**BOARD OF ADJUSTMENT MEETING**  
**August 25th, 2025 – 4:30 p.m.**  
**City Council Chambers**  
**Fremont Municipal Building**  
**400 East Military Ave.**  
**Fremont, Nebraska**

## Staff Report

**SUBJECT:** Request for variance of Section 11-820 to permit greater sign area and height than allowed in the UDC

# SIGN 7

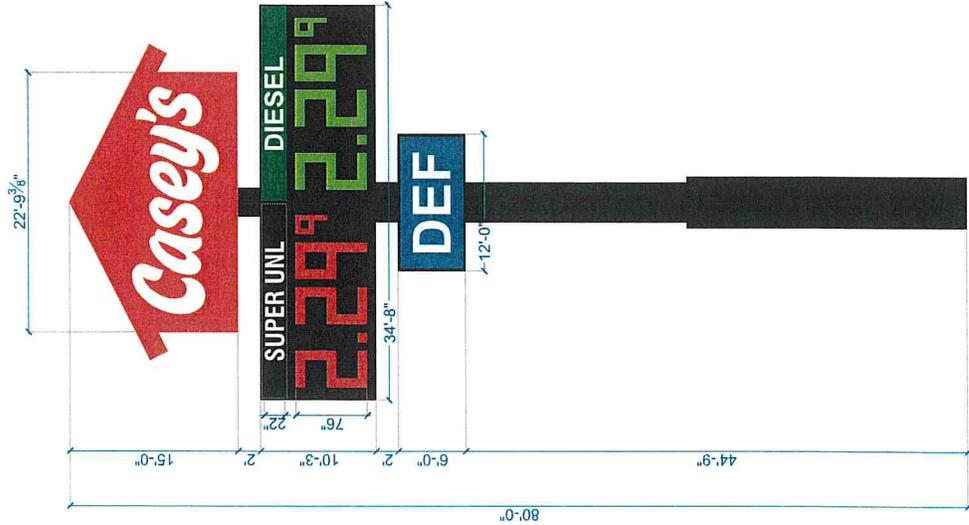
1. The proposed signage would be 60% larger than the allowable square footage and 33% taller than the allowable pole sign height.
2. No other commercial facilities in the GC Zoning Districts have signage of the proposed area or height.
3. In the original application submitted by Casey's square footage was under the maximum allowable sf of 450 sf, the applicant stated the following:

In the revised application received Aug 19, 2025, that applicant is requesting 56" lettering for a total of 720sf per sign face.
